# **APPENDIX 1**

# PHOTO 1

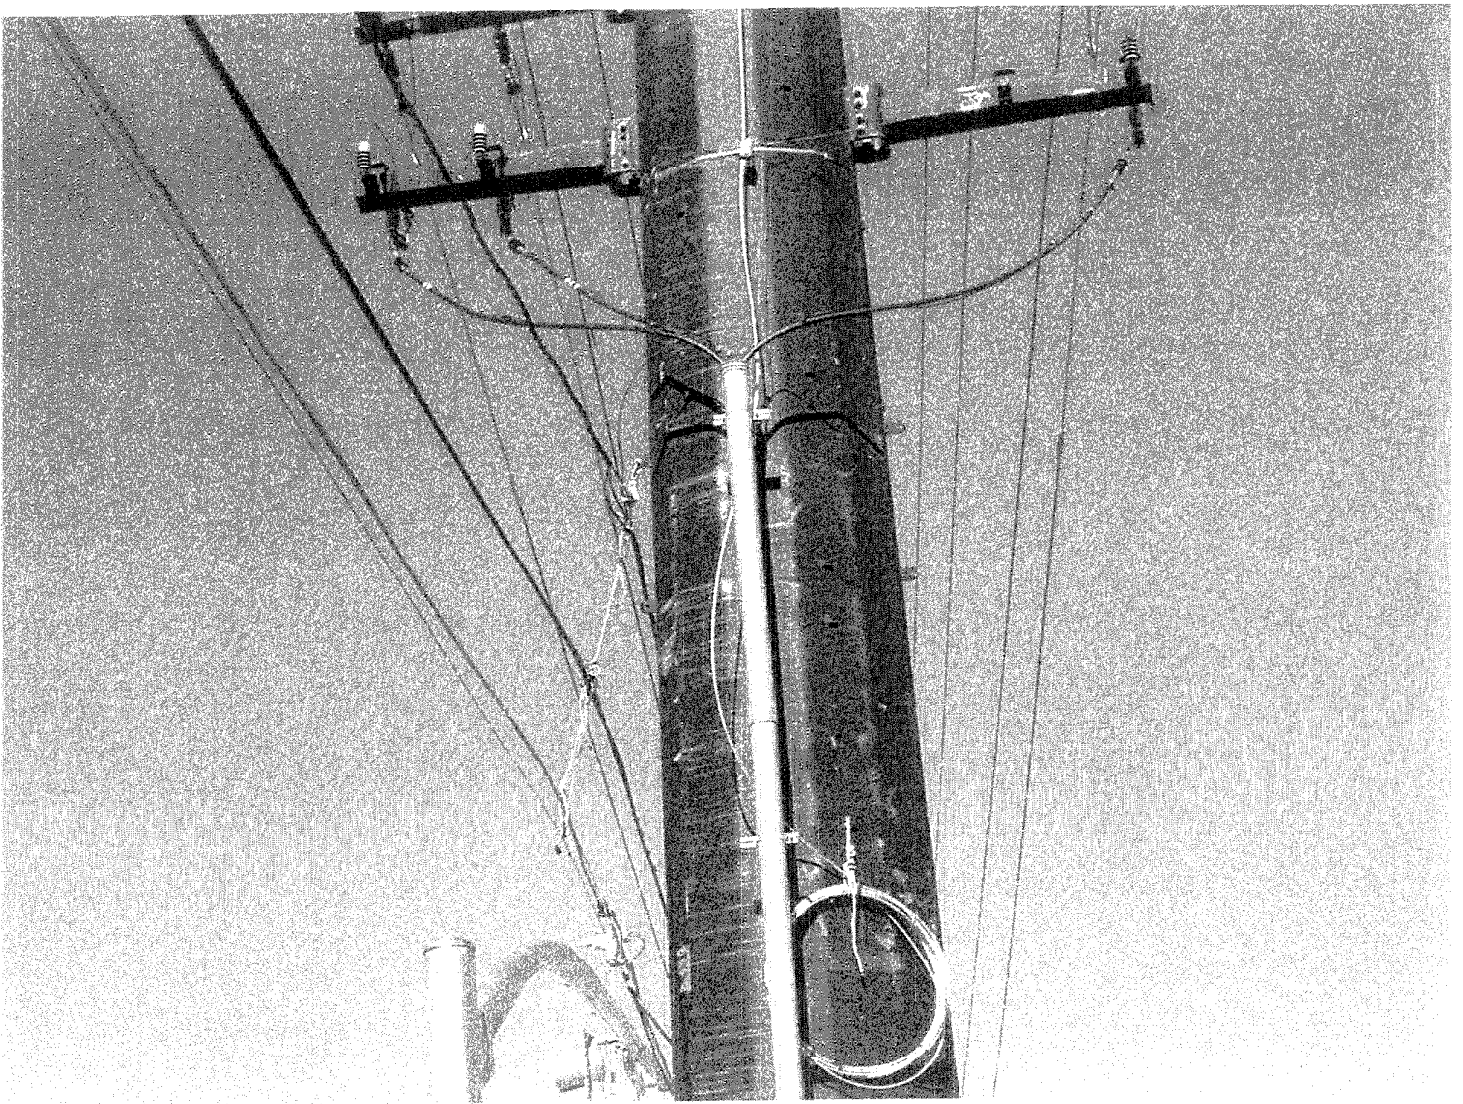
This is the pole that I mentioned in my initial testimony. The power company transferred Comcast's cable from the old pole to this new large black transmission structure and "secured" the Comcast cable to electric conductors above it with rope. This is a very unsafe practice because the rope deteriorates quickly in the sunlight and breaks. PacifiCorp, as is its current practice, provided no notice to Comcast that it was doing this.

#### PHOTO 4

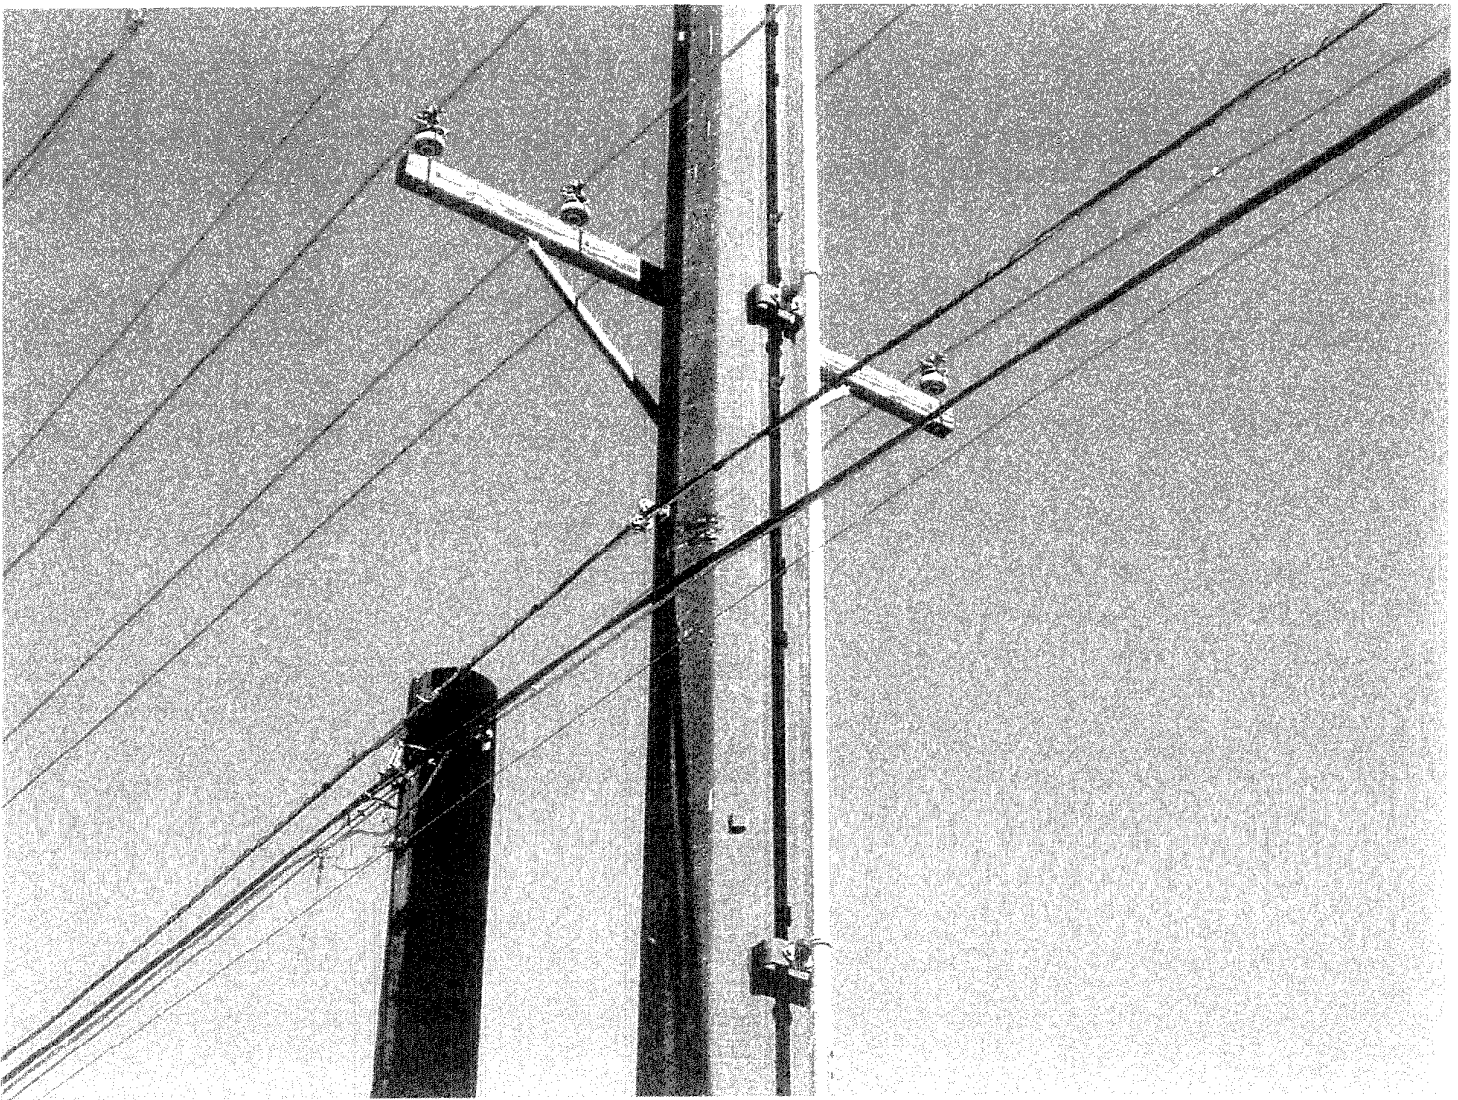
This photo shows a number of very unsafe PacifiCorp construction practices. It can be clearly seen that PacifiCorp has left an (ungrounded) primary voltage cable looping out of the riser conduit, behind the pole, under communications and then coiled on the opposite side of the pole around the lower cross arm. This violates a number of clear-cut safety standards including work rules in NESC Part 4 and the PacifiCorp construction standards. This photo also shows that the street light lead is less than 12 inches above the communications cable. The cable tv line has been in place for many years. It is likely that the light has been placed or replaced after the cable was installed.

## PHOTO 5

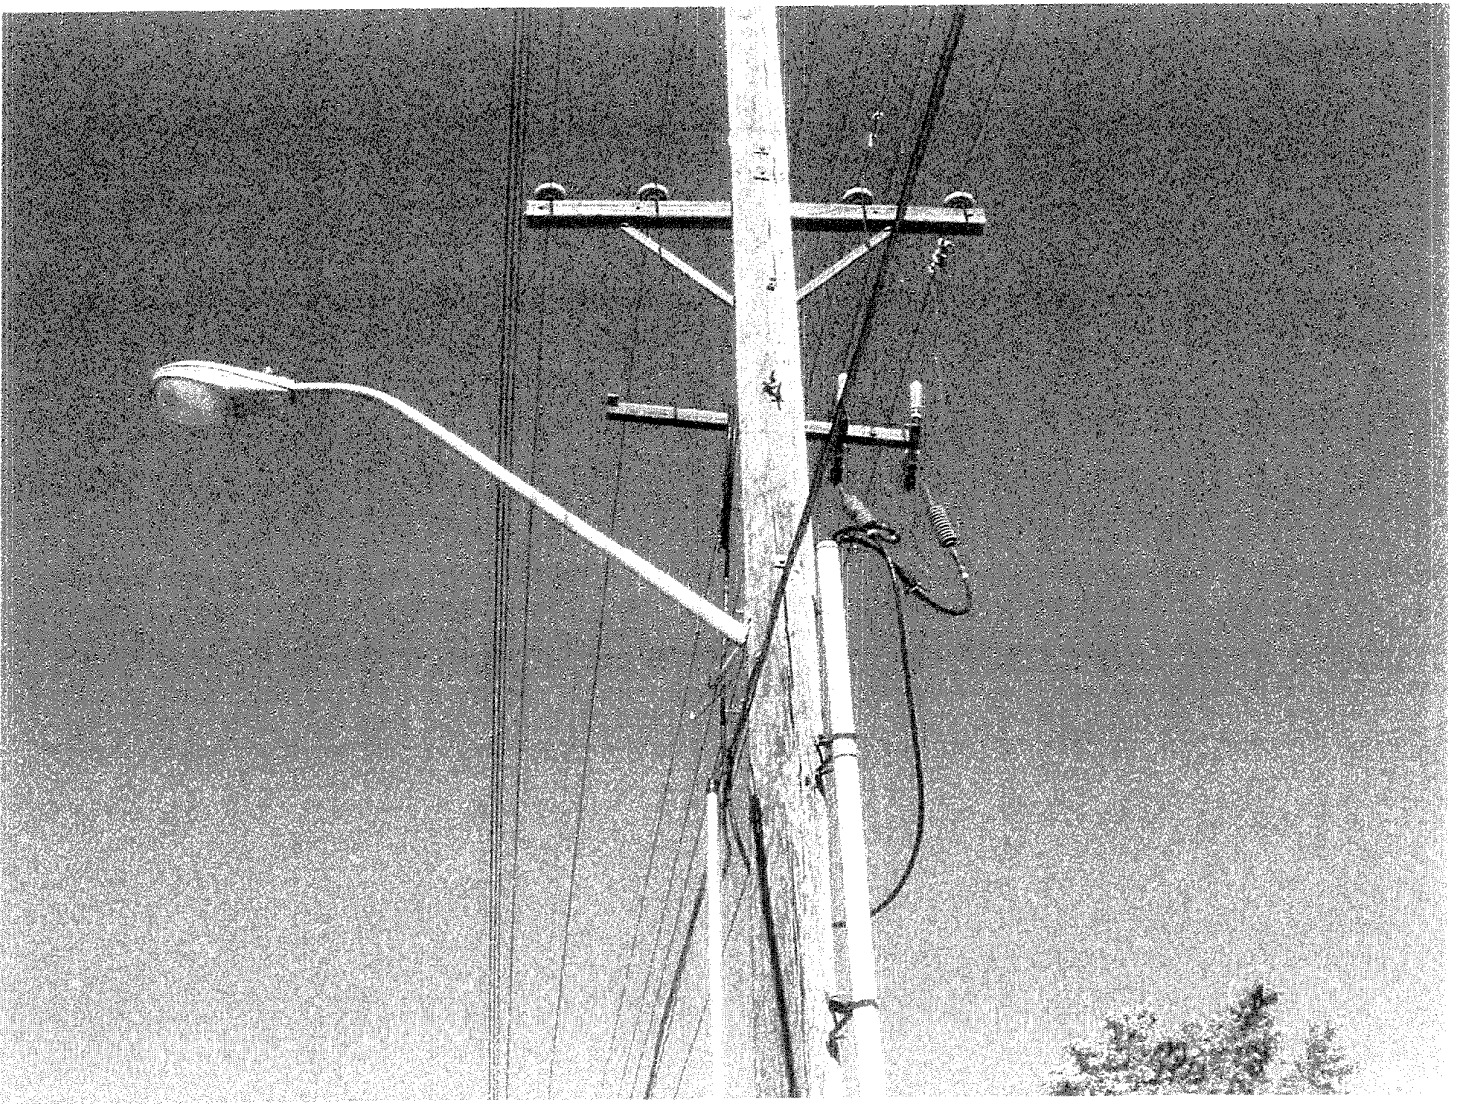
The next two photos show situations in which I believe that PacifiCorp has acted unreasonably with respect to Comcast because PacifiCorp refused to re-sag its lines. It could have done this with minimal expense. It refused, and Comcast was forced to bury its cable underground.

The first photo depicts the Comcast cable, the lowest on the pole, going down metal conduit risers down the pole and underground because the power line sags too low and PacifiCorp was unwilling to re-sag it.

## PHOTO 6

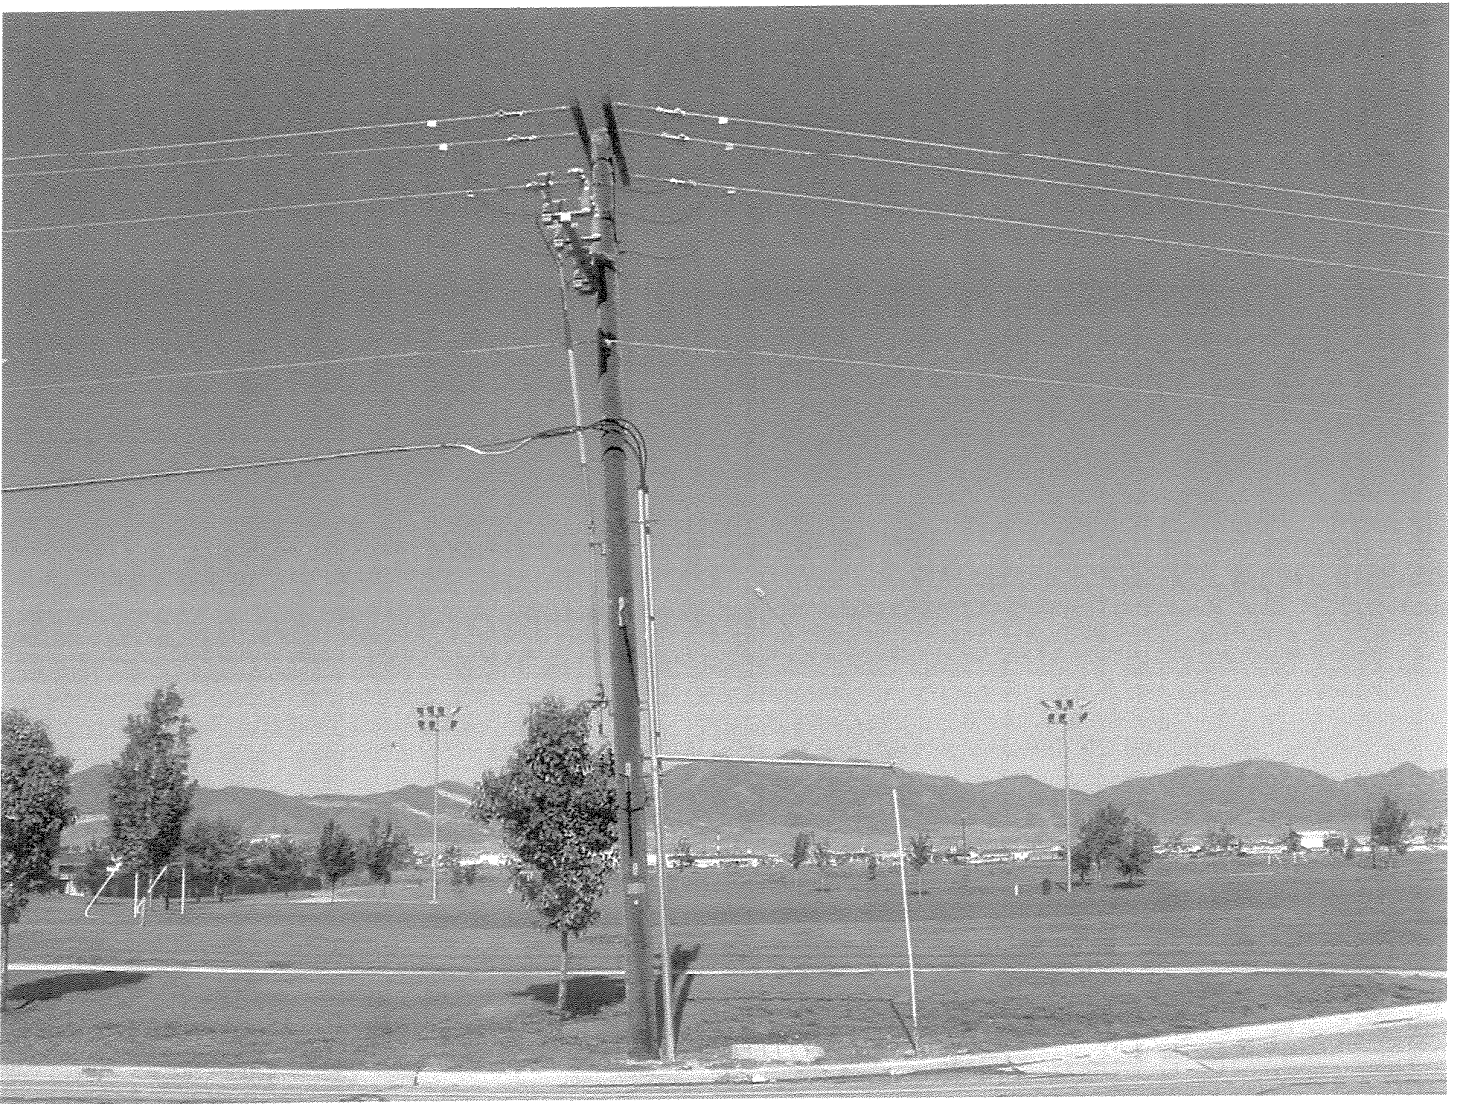
This photo shows the same pole depicted in the previous photo, and shows the deep sag in the electric facilities that the power company was unwilling to fix.

## PHOTO 8

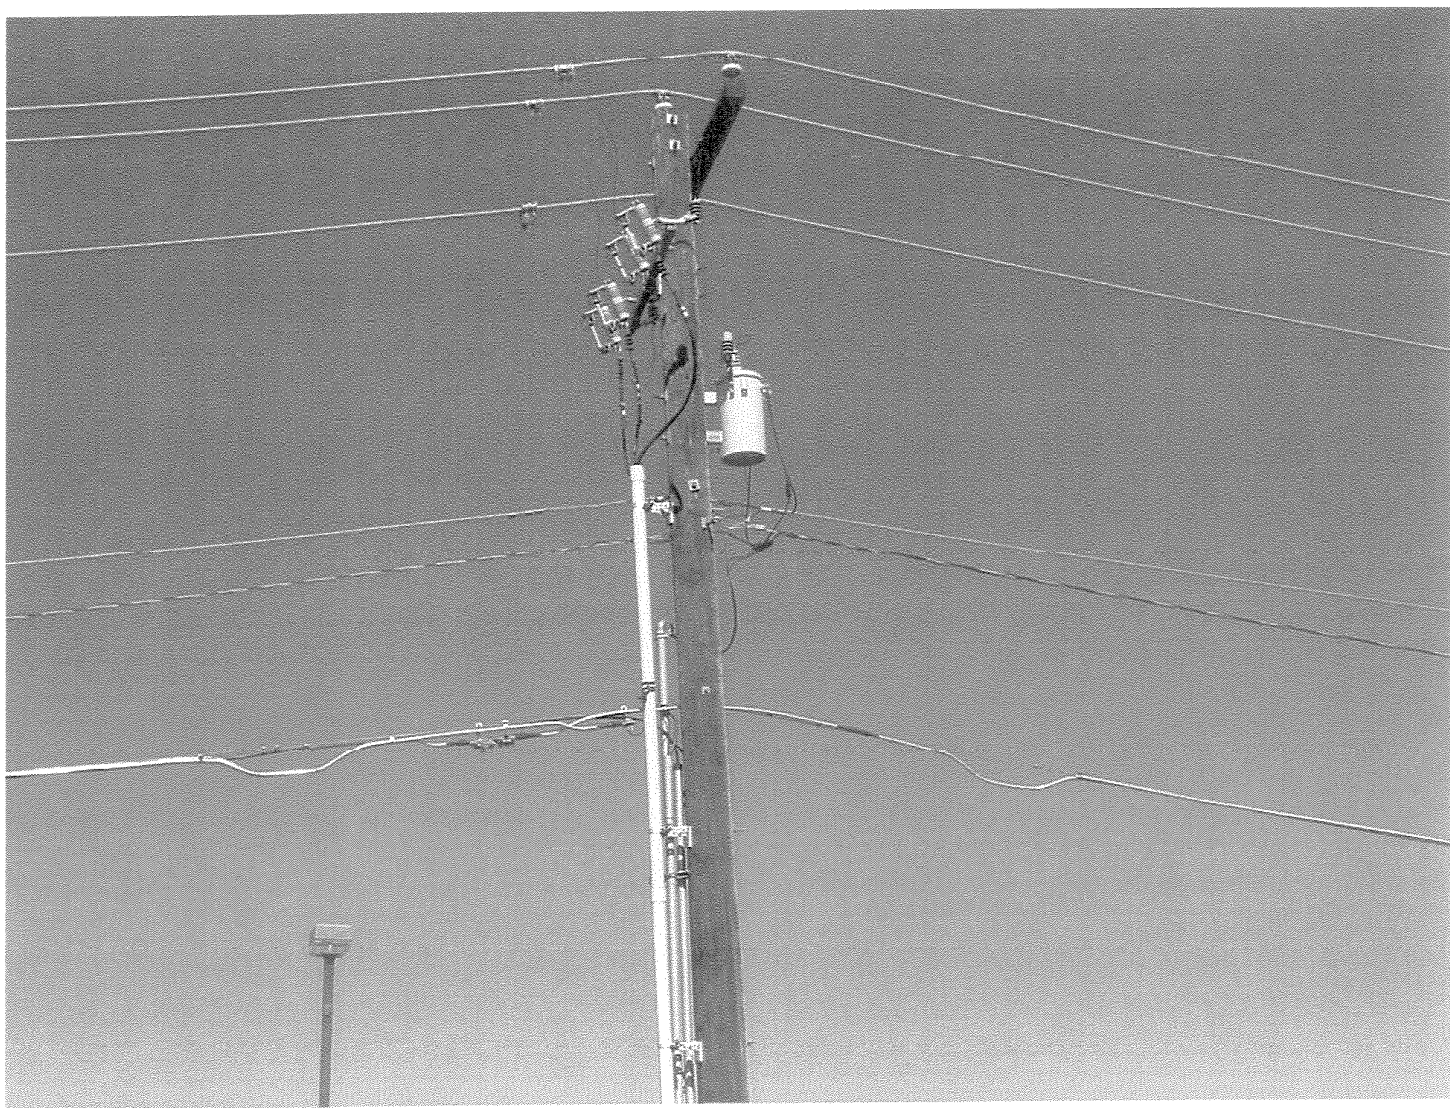
The next two photos show very clearly that the electric utility has a secondary connection to a weather head that is much lower than the required 40" clearance for this sort of configuration. The next photo shows a similar violation.

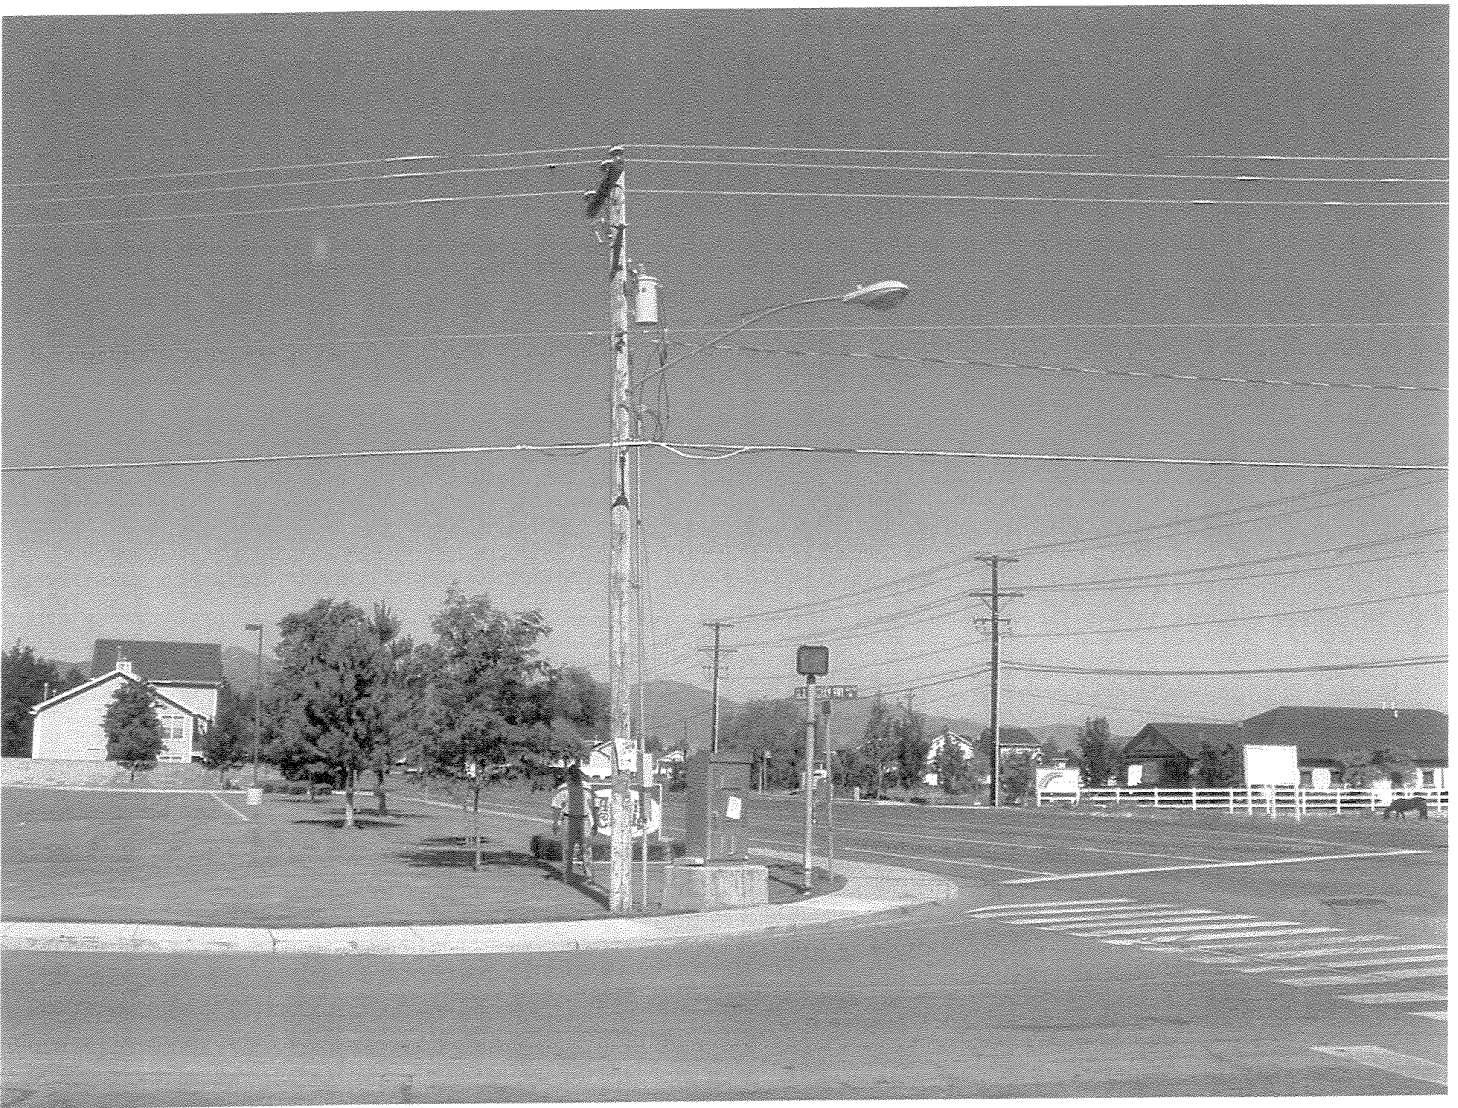
This is another example of another weather head violation of the communications space. Notice that the power loops coming out of the transformer and into the weather head actually dip below the cable tv line at the bottom of the pole. The cable tv facility has been there for years, and the power to the traffic signal controller is relatively new. Comcast's Rodney Bell is very familiar with Comcast's plant and informed me that the cable plant was already in place when the electric line was connected to the weather head.
